## PROPOSED NEW ACCESS, OXENRIGGS FARM 4/24/2296/0F1

I am response to the objection letter written by Micheal Sandilands on behalf of a neighbour. We would like to respond as follows; (Extracts from letter in black and our response in blue)

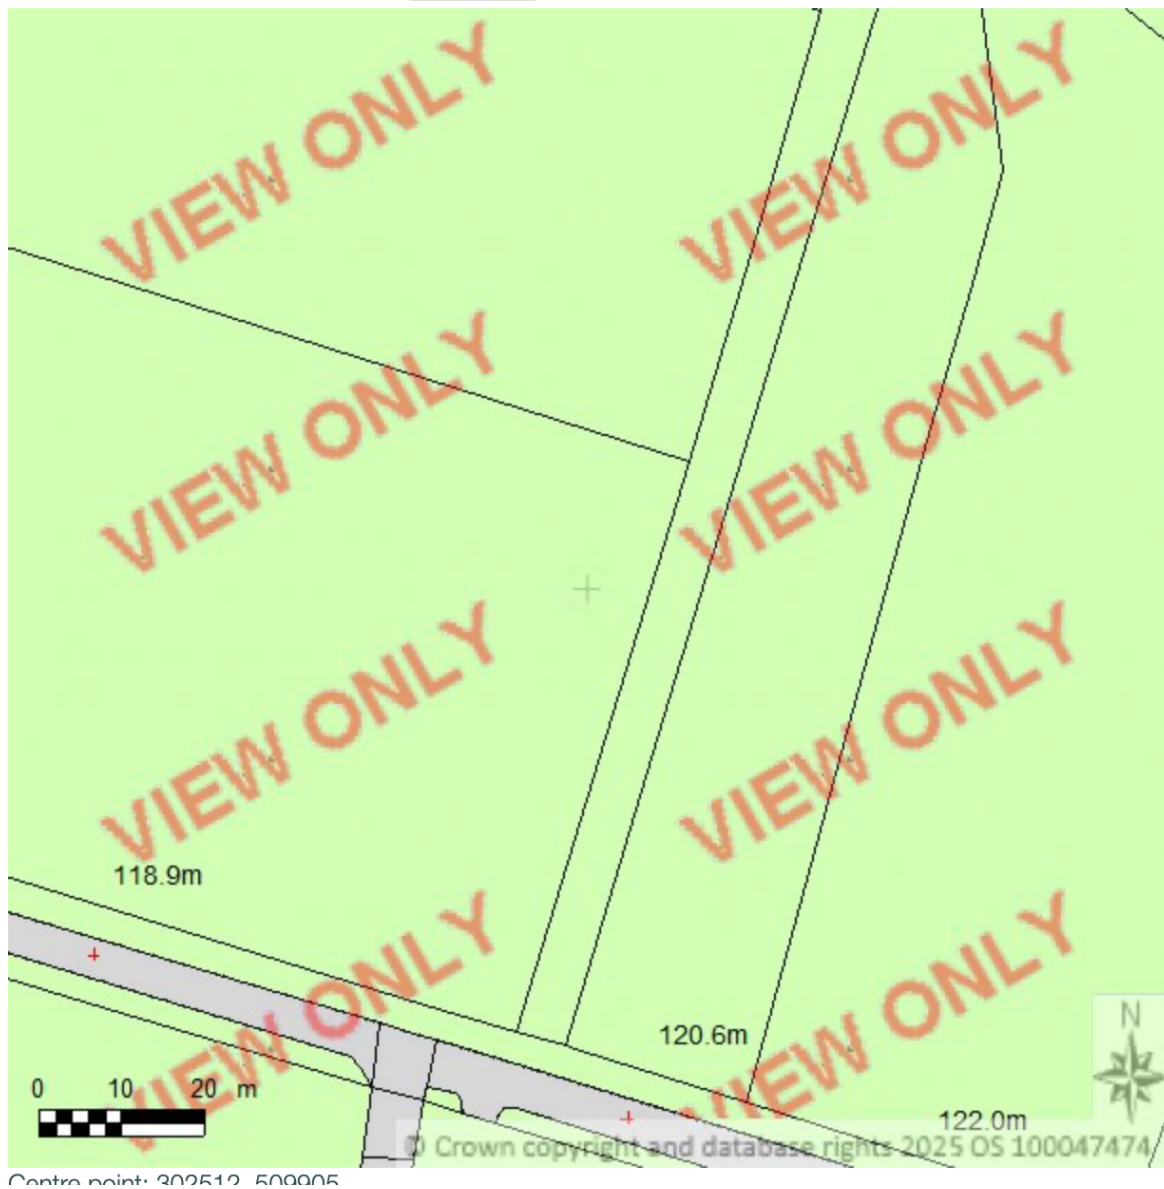
2. There is no existing track to reinstate or upgrade. The photos contained on page 4 of the Planning Statement appear to show that materials have been tipped on the site of the proposed track and this does not in itself suggest that the track already exists. Indeed, the fact that the purported existing track does not lead anywhere suggests it is not a track.

The description of the development appears to have been misleading and should be amended accordingly. The application should be treated as an entirely new development and no weight should be given to the fact that any element of the proposed development is reinstatement.

The track does already exist. The strip of land is fenced off on either side and already has hardcore surfacing. This is supported by the Google image below;

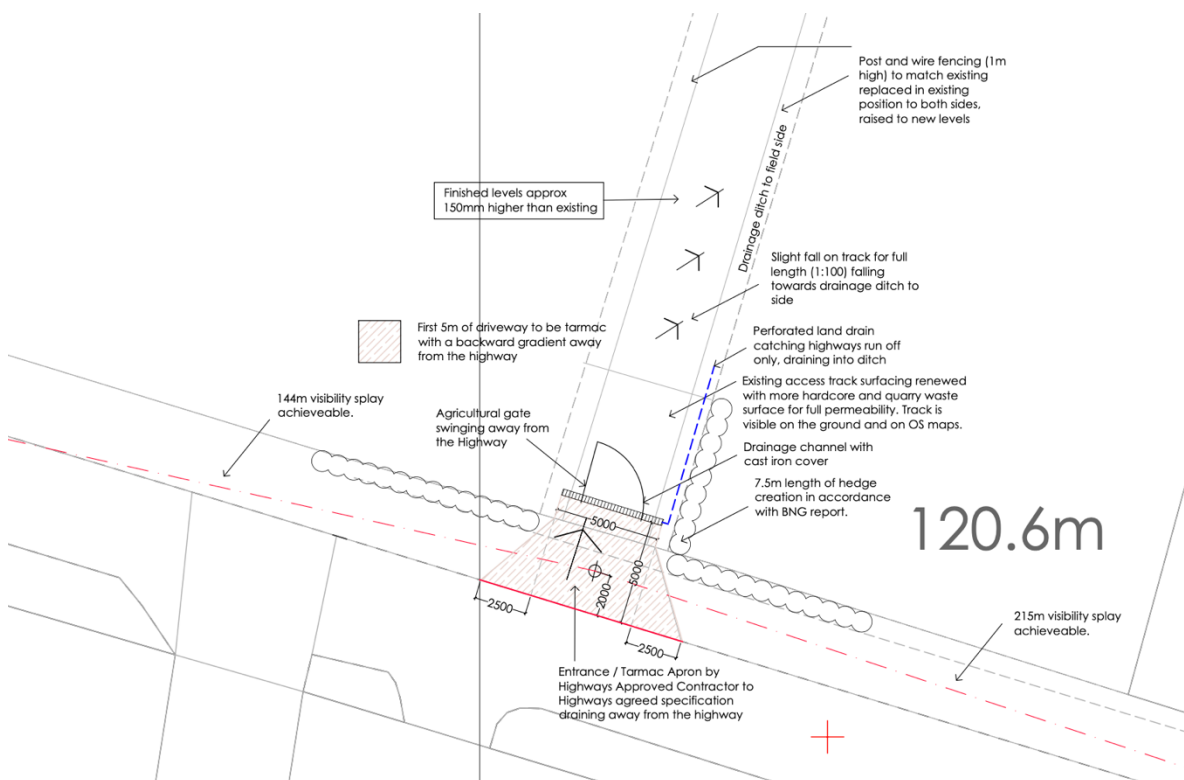
3. In light of the above the Planning Authority should give appropriate consideration to landscape impact. It is apparent from the Planning Statement that no consideration has been given to the subject of landscape impact which is of course a material planning consideration. A proper assessment should be undertaken with reference to landscape character and the landscape harm of constructing a new track in this location.

Track is already constructed as evidenced above with fencing and hedging both sides. The hardcore can be seen on the surfacing below, while the level of the existing track is also higher than

the adjacent land. The upgrade of the track therefore has little landscape impact. The upgrade in terms of Biodiversity is however considered and compensated in the BNG report attached to the application.
